<b>Well Name:</b> SAKER 6-7 FEDERAL COM	<b>Well Location:</b> T24S / R35E / SEC 6 / LOT 1 / 32.253325 / -103.39994	<b>County or Parish/State:</b> LEA / NM
<b>Well Number:</b> 5H	<b>Type of Well:</b> OIL WELL	<b>Allottee or Tribe Name:</b>
<b>Lease Number:</b> NMNM014164	<b>Unit or CA Name:</b>	<b>Unit or CA Number:</b>
<b>US Well Number:</b> 3002549457	<b>Operator:</b> OXY USA INCORPORATED

### Notice of Intent

**Type of Action:** APD Change

**Procedure Description:** Oxy USA Inc., respectfully requests approval to amend the subject well AAPD to change the SHL, BHL, Pad and amend the casing to our 3-string slim w/ T95 production casing design. See attached APD sundry change overview worksheet along with the updated well plat and drilling documents. The surface hole is moving to an existing pad. "The SHL is moving 145' to the east and there is no additional surface disturbance related to this sundry"

### 1. Cement Program

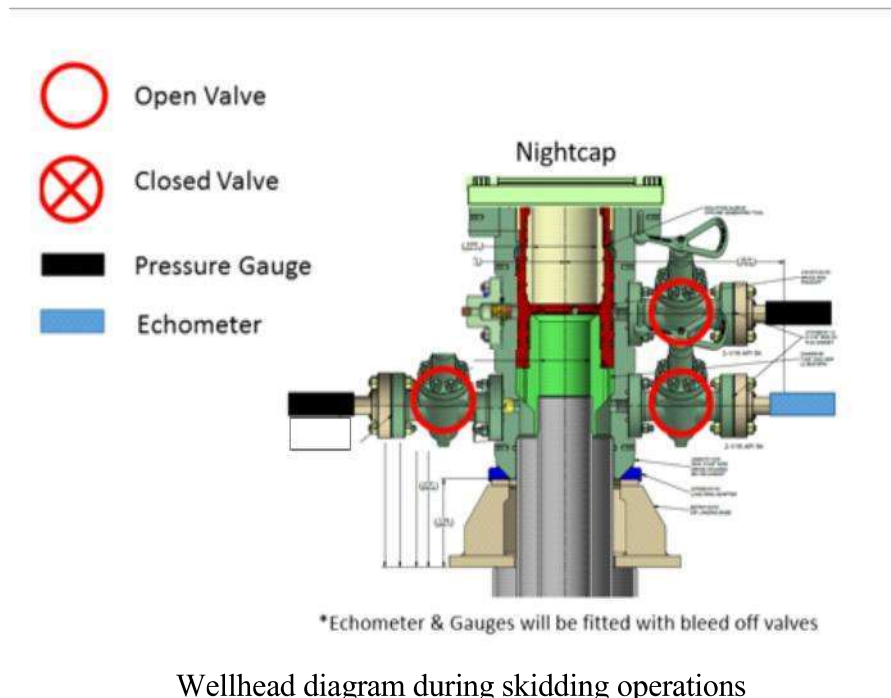
Oxy requests a variance to cement the 9.625" and/or 7.625" intermediate casing strings offline in accordance to the approved variance, EC Tran 461365.

No changes to the cement program will take place for offline cementing.

Operator has been (Approved) to pump the proposed cement program offline in the Surface and intermediate(s) intervals.

Offline cementing should commence within 24 hours of landing the casing for the interval.

Notify the BLM 4hrs prior to cementing offline at **Lea County: 575-689-5981**.

Wellhead diagram during skidding operations

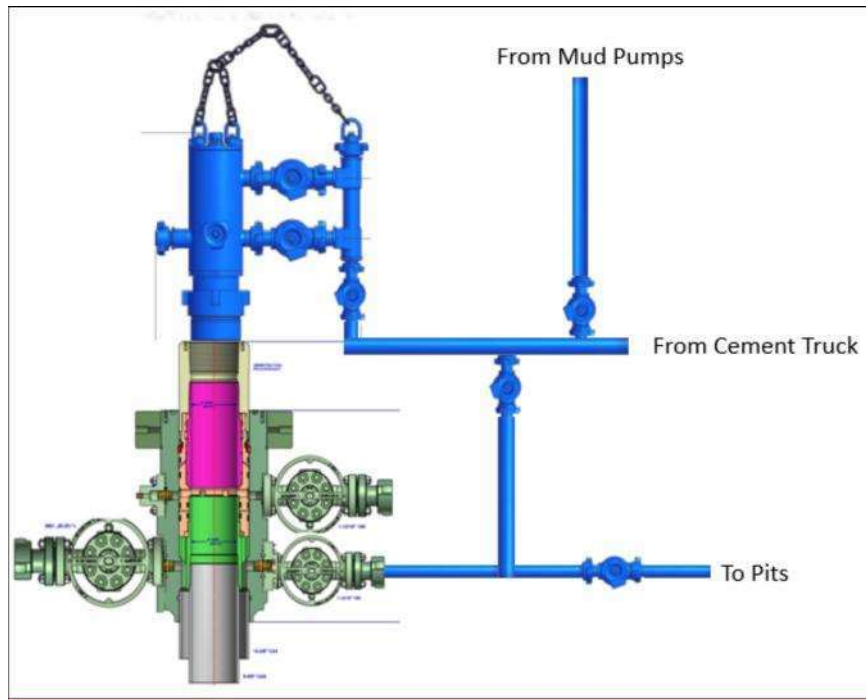
1. Run casing as per normal operations. While running casing, conduct negative pressure test and confirm integrity of the float equipment (float collar and shoe)
2. Land casing with mandrel
3. Fill pipe with kill weight fluid, do not circulate through floats and confirm well is static
4. Set annular packoff shown below and pressure test to confirm integrity of the seal.  
Pressure ratings of wellhead components and valves is 5,000 psi

5. After confirmation of both annular barriers and internal barriers, nipple down BOP and install cap flange.
  - a. If any barrier fails to test, the BOP stack will not be nipped down until after the cement job is completed with cement 500ft above the highest formation capable of flow with kill weight mud above or after it has achieved 50 psi compressive strength if cannot be verified.

Form C-102  
Revised August 1, 2011  
Submit one copy to appropriate  
District Office

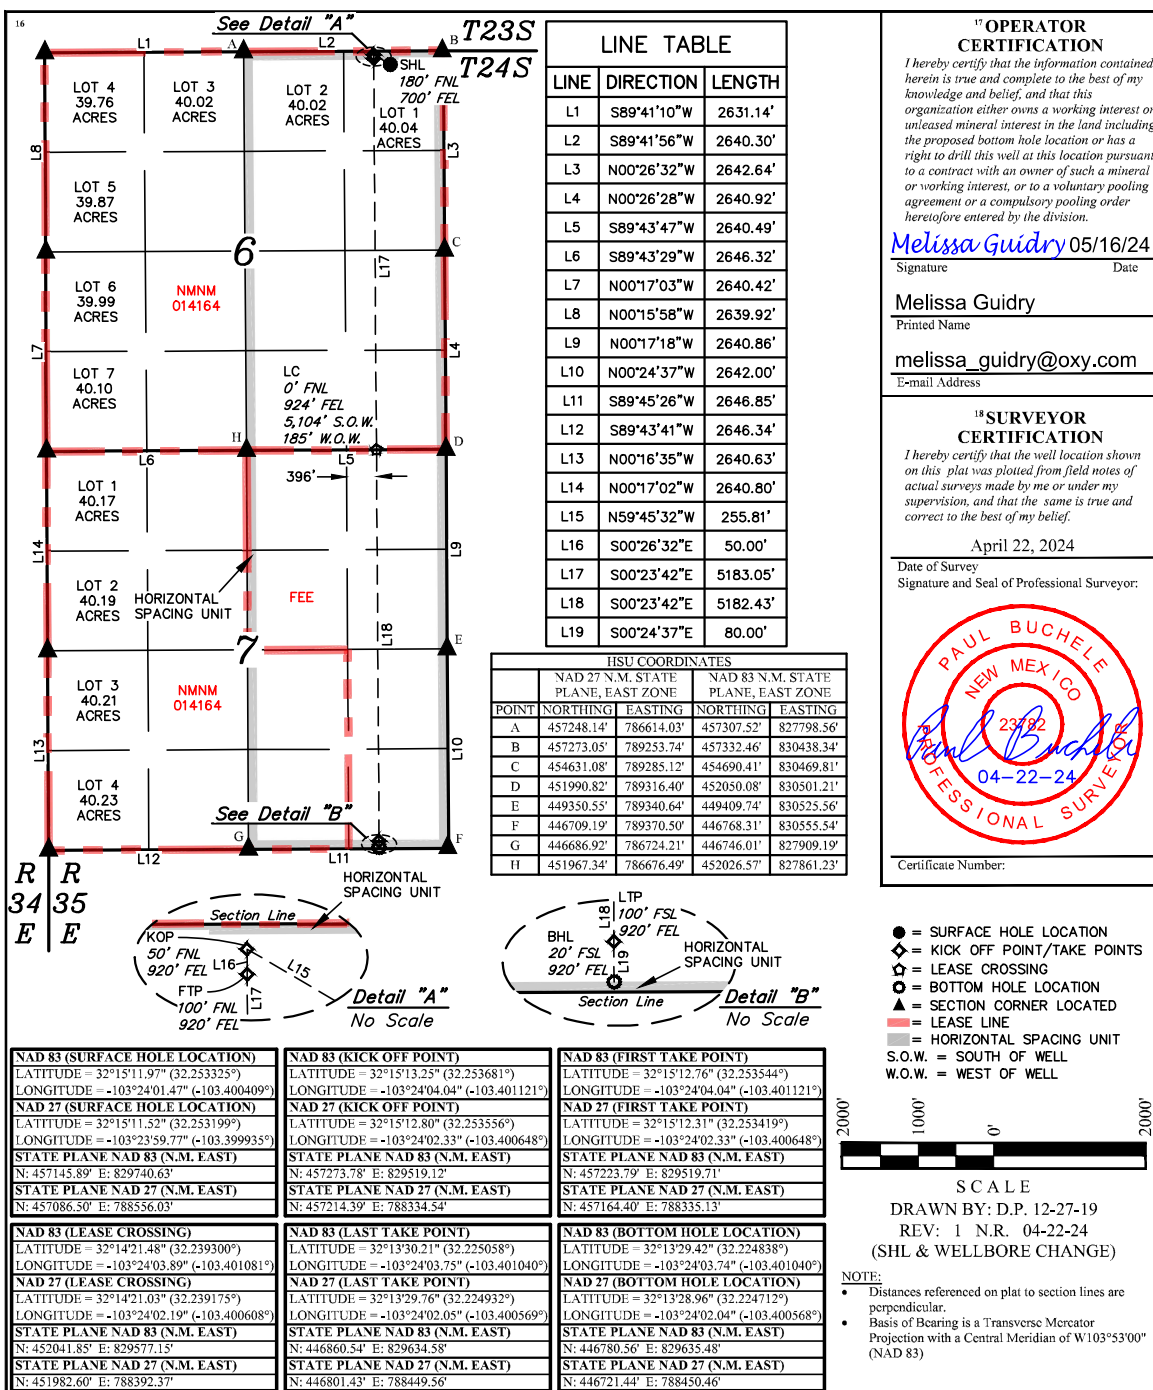
"The SHL is moving 145' to the east and there is no additional surface disturbance related to this sundry"

ITEM	PREVIOUS PLAN	UPDATED PLAN
Surface Planning	NAME	SAKER 6_7 FEDERAL COM 5H	N/A
	NSL	N/A	N/A
	SHL	180 FNL 555 FEL	180 FNL 700 FEL
	PAD	Falcon Ridge 0605 PAD	Falcon_T24SR35E_6_Pad 3
	BHL	20 FSL 1260 FEL	20 FSL 920 FEL
	HSU SIZE, ACRES	640.06	N/A
	POOL	Bone Spring	N/A
	TARGET FORMATION	Avalon	SECOND BONE STRING SANDSTONE
Drilling	TVD	19323'	20780'
	SURFACE CASING	17.5 in, 13.375 in, 54.5 lbs, J-55 BTC	14.75 in, 10.75 in, 45.5 lbs, J-55 BTC
	INTERMEDIATE CASING	12.25 in, 9.625 in, 40 lbs, L-80 BTC	9.875 in, 7.625 in, 26.4 lbs, L-80 HC BTC
	INTERMEDIATE 2 CASING	NA	N/A
	PRODUCTION CASING	8.5 in, 5.5 in, 20 lbs, P-110 DQX	6.75 in, 5.5 in, 23 lbs, T-95 Edge SF+
	LINER OR TIE BACK	NA	N/A
	CEMENT - SURFACE (TAIL)	876 sxs, 14.8 lb, 1.33 yld, Class C + Accel	696 sxs, 14.8 lb, 1.33 yld, Class C + Accel
	CEMENT - INTERM (TAIL)	155 sxs, 14.8 lb, 1.33 yld, Class C + Accel	262 sxs, 13.2 lb, 1.68 yld, Class C + Ret., Disper
